# SITE PLAN AND ARCHITECTURAL REVIEW COMMITTEE

**CITY OF LODI  
SITE PLAN AND ARCHITECTURAL REVIEW  
COMMITTEE  
Staff Report**

**APPLICATION NO:** PL2020-028

**REQUEST:** Approval of a proposed development of a new 56,162-square-foot 2-story, 78 unit senior housing facility and associated site improvements on an approximately 2.16-acre site at 1108 Sylvia Drive (Applicant: Michael Frazier; File Number: PL2020-028; CEQA Determination: Exempt Per Section 15332)

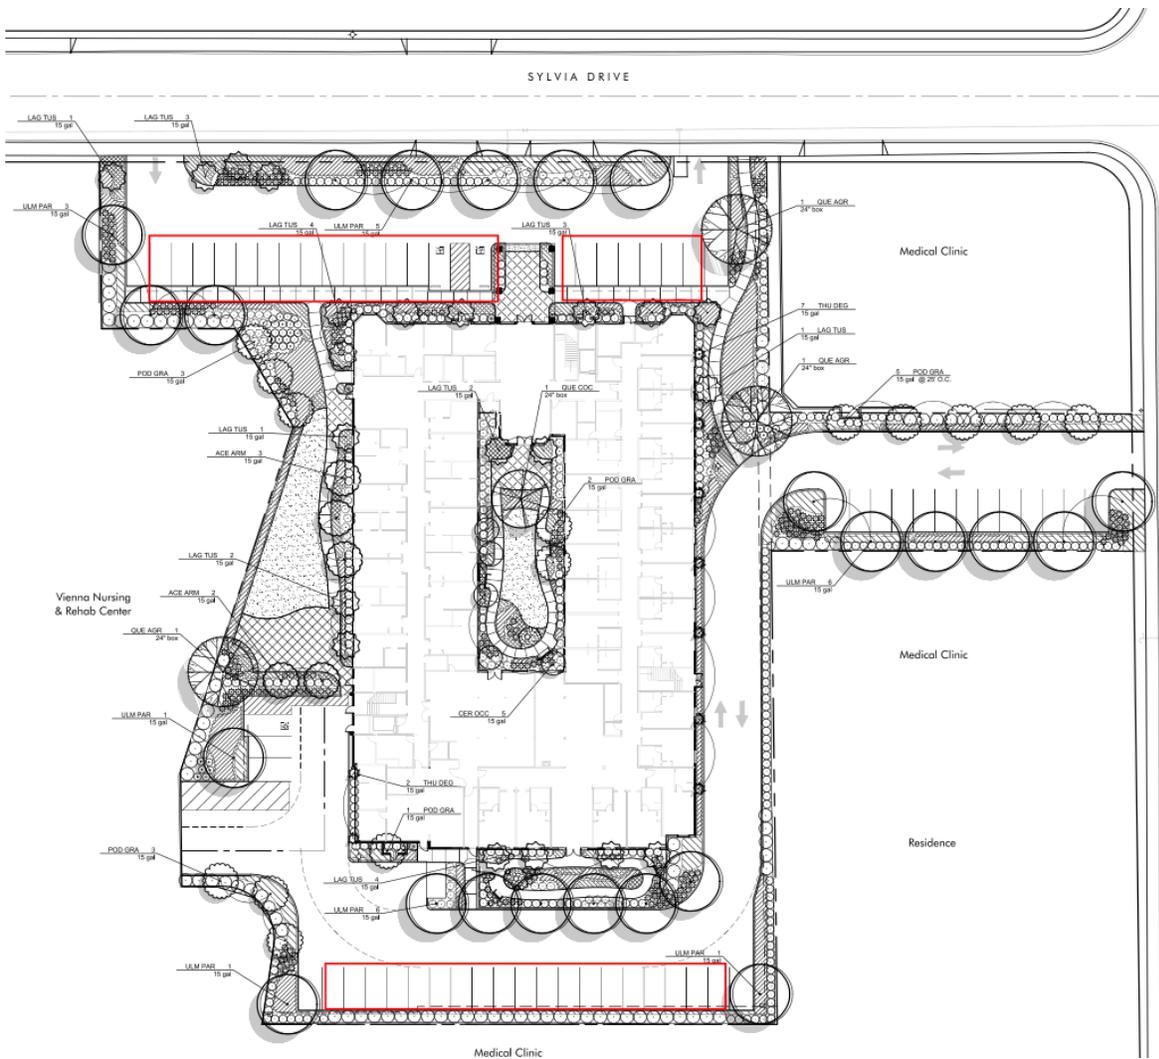
The Lodi Zoning Code seeks to ensure that parking areas will have shade for both aesthetics and for the comfort of patrons and employees. The most direct standard is:

*"Landscaped areas within or adjacent to the parking area shall provide for a minimum of one shade tree for every four parking stalls. Depending on type and size of shade tree, requirements may be modified by the City Site Plan and Architectural Review Committee."* [Zoning Code 17.32.070.D.2]

Staff interprets this requirement to require that parking spaces alternate with trees every fourth space, providing shade throughout the parking lot. Staff views this as important in this particular case for the comfort of both visitors and staff, especially during Lodi's hot summer months.

However, as shown in the applicant's submittal, most of the parking spaces (approximately 41 of 60) have no shading:

The applicant has indicated that shading will be provided via:

- Adding trees to the parking area adjacent to Sylvia Drive
- Shading the spaces on the southern project boundary with solar panels

Both of these solutions are acceptable to staff. Recommended conditions of approval are included to require the submittal of revised plans showing sufficient shading before building permits are issued.

14.	The applicant shall provide revised landscaping plans showing compliance with shading requirements for the parking area that include either one tree for every four parking spaces (alternating trees and parking spaces) or another method acceptable to the Community Development Director to provide shade (such as solar panels or a similar shade structure).	Prior to issuance of building permit	Planning Division

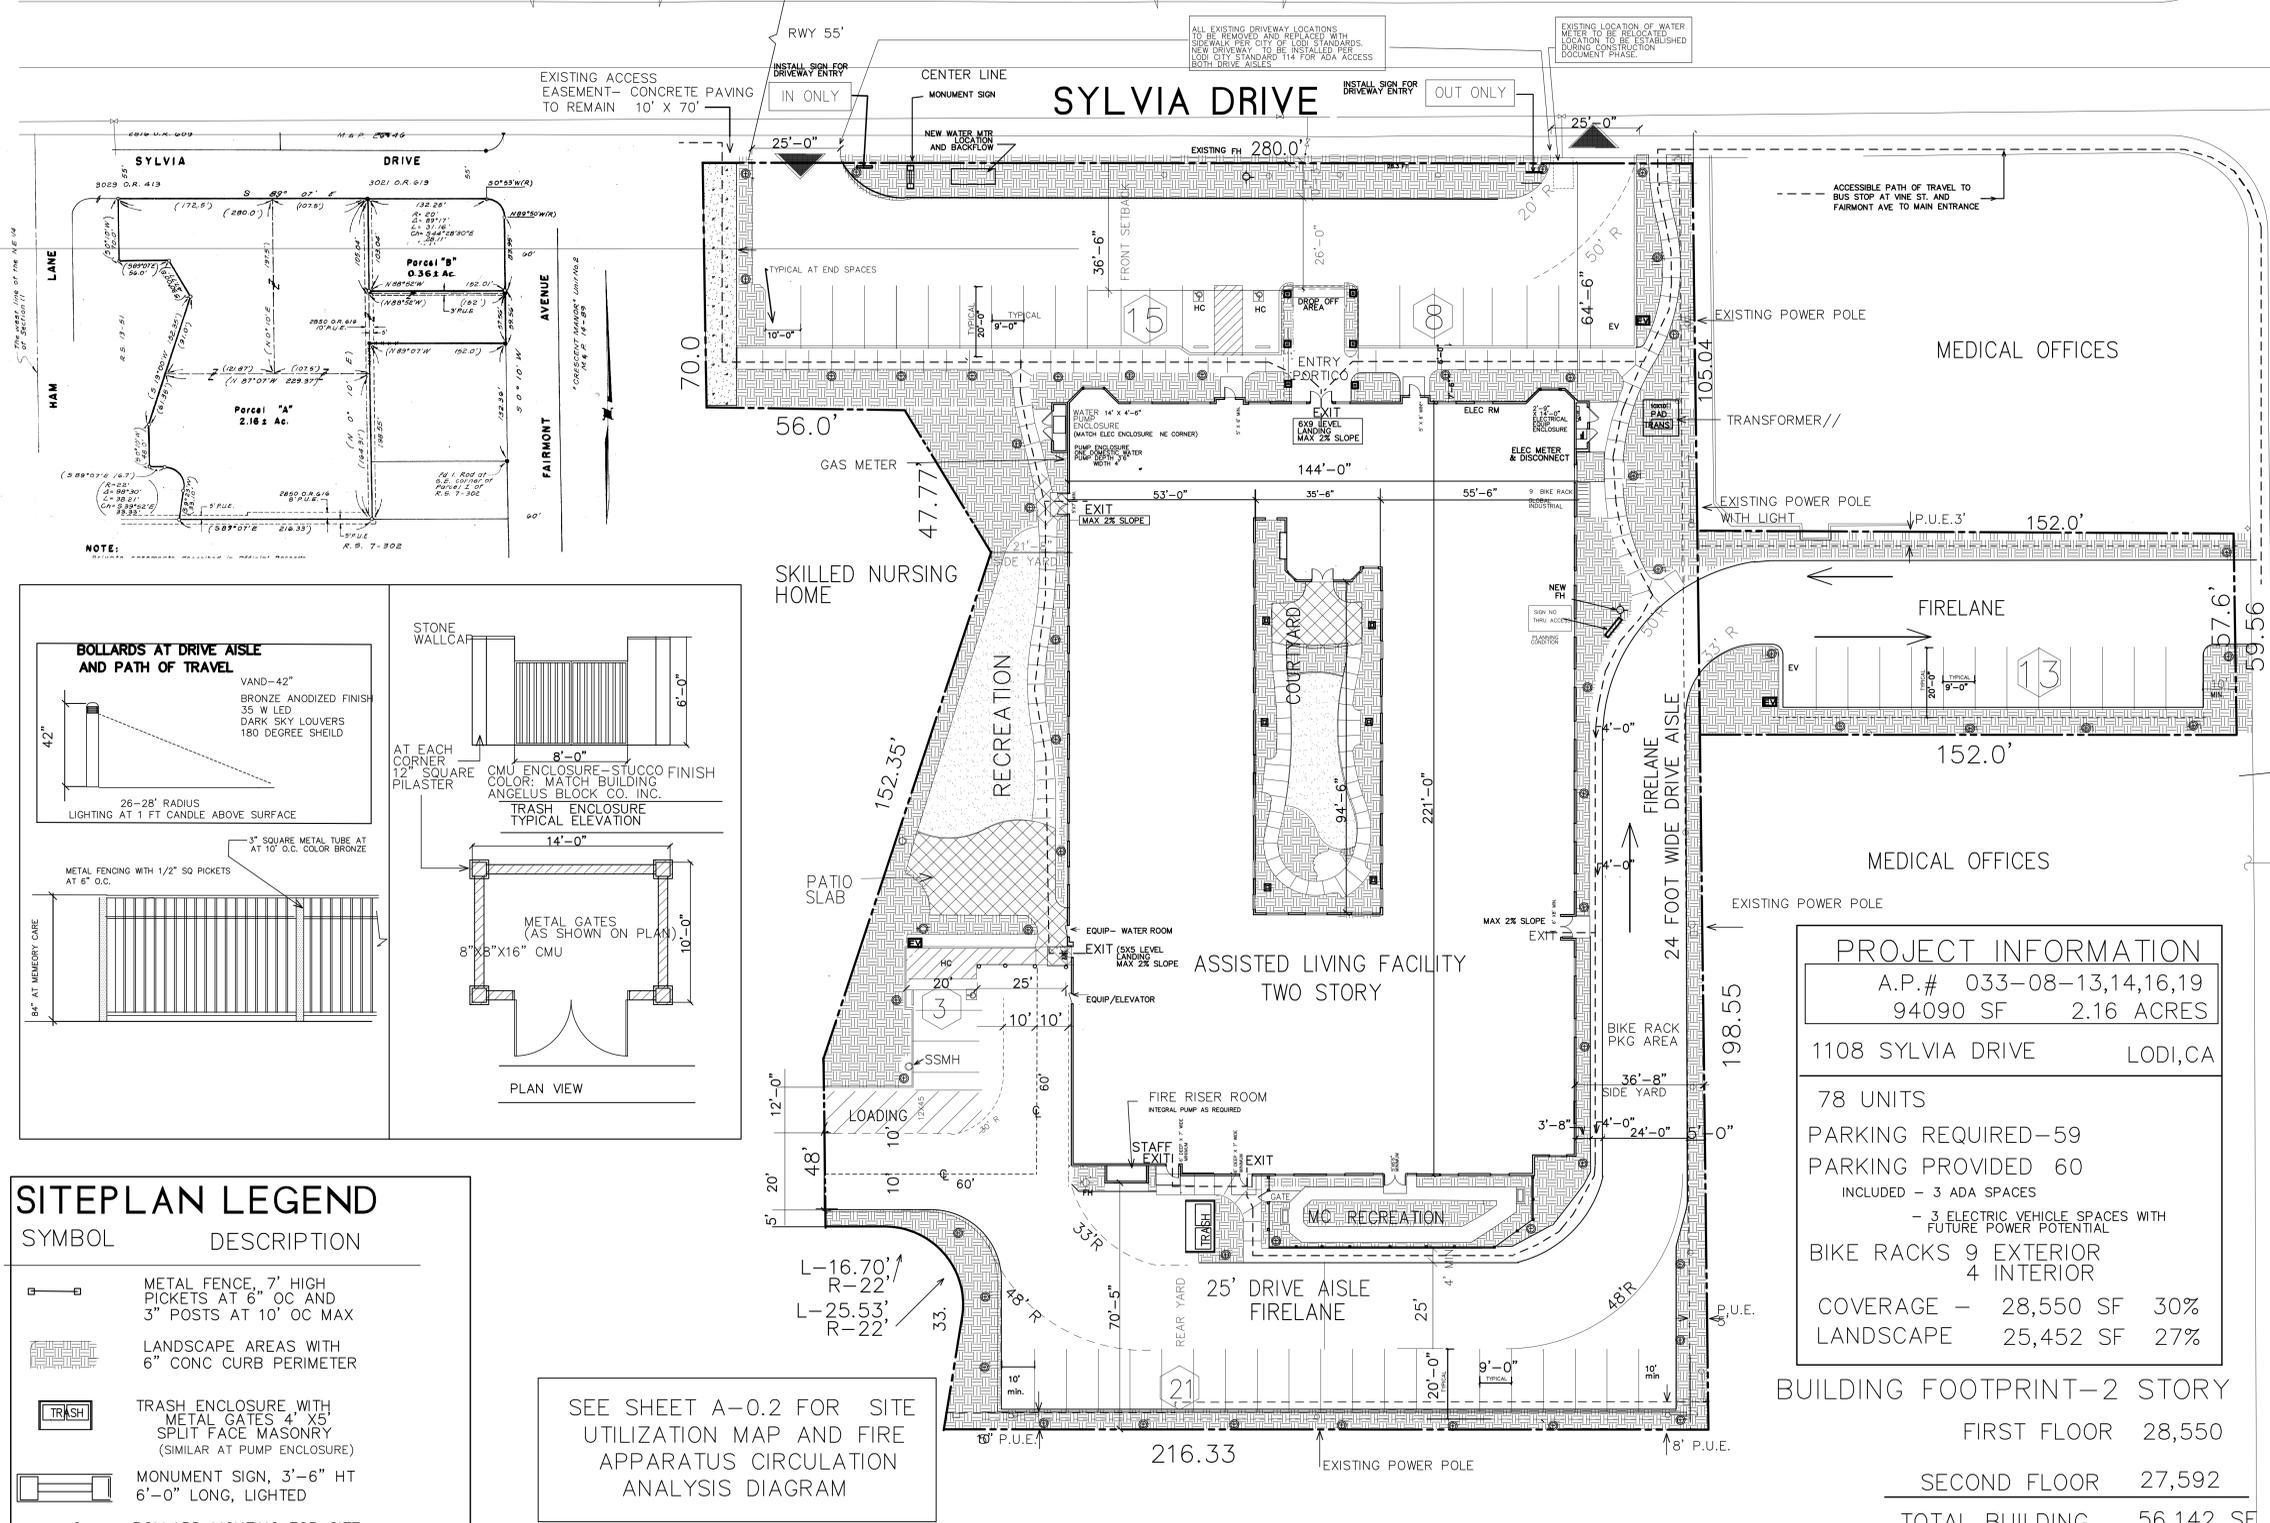
Staff is in general agreement with the proposed design, which is the result of discussion between staff and the applicant. However, staff suggests the following minor additions to the stone accents on the building, and has included a proposed condition of approval to require additional stone accent material in these locations:

- Extending the stone accent material upward on all sides of both corner turrets in the locations shown.
- Extending the stone accent material upward on both the building and the supports of the entry feature in the locations shown.

15.	The applicant shall complete a Parcel Merger to combine the four existing parcels.	Prior to issuance of building permit	Planning Division	
16.	The applicant shall submit revised elevations which show the use of the stone accent material in the areas shown in the figure below. This shall

## ELECTRIC UTILITY DEPARTMENT Memorandum

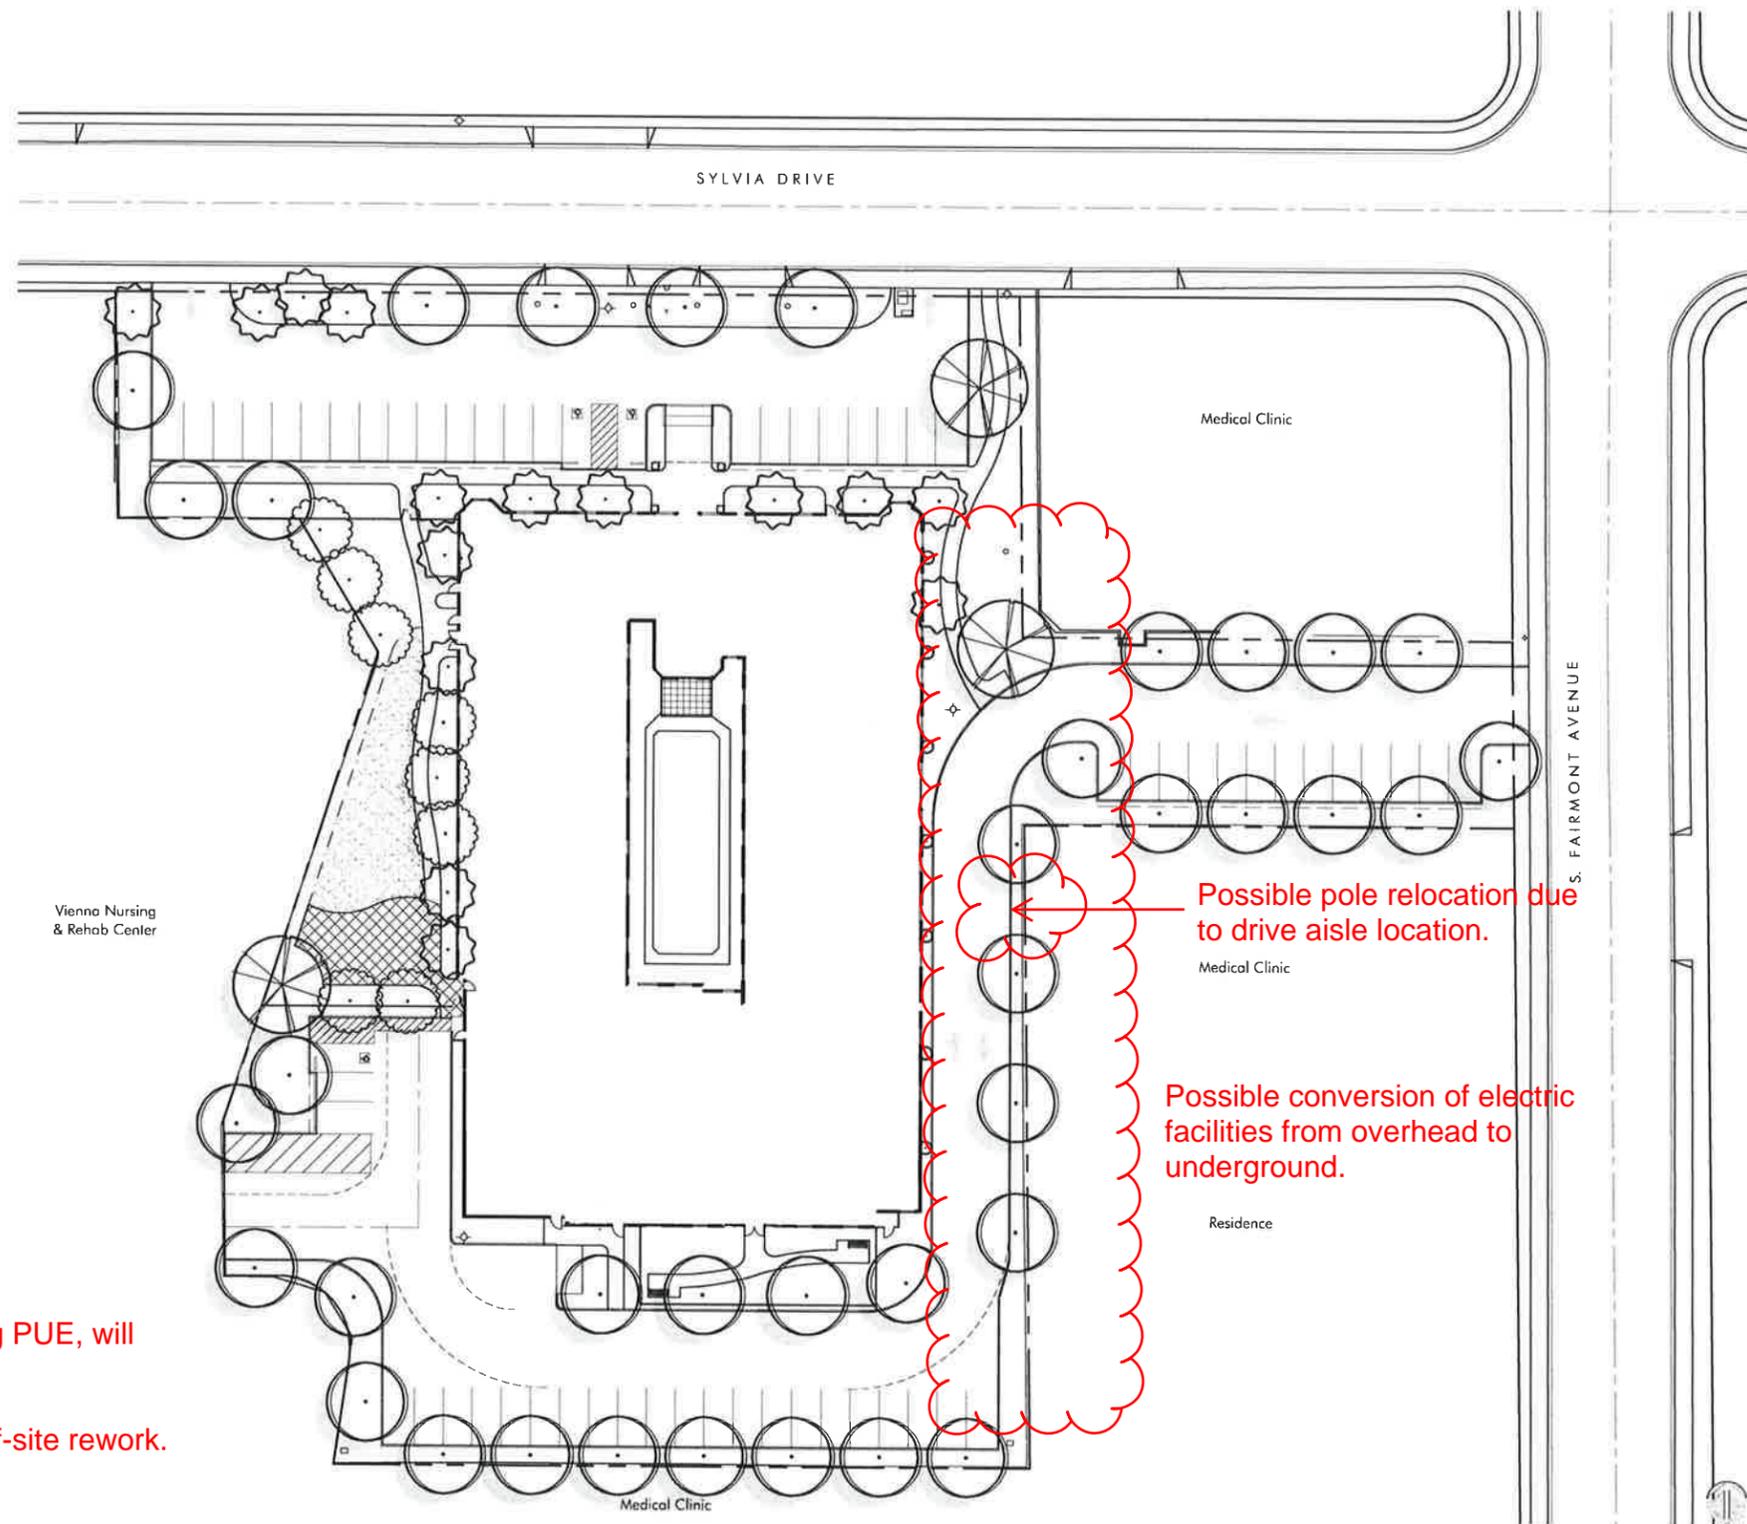
**TO:** Applicant of Senior Assisted Living / Memory Care Facility, 1108 Sylvia Dr.  
**FROM:** Sr. Power Engineer, Tim Conn  
**DATE:** September 22, 2020  
**SUBJECT:** Site plan comments

The Electric Utility recently reviewed a site plan for a proposed Senior Assisted Living / Memory Care Facility at 1108 Sylvia Drive and provides the following comments:
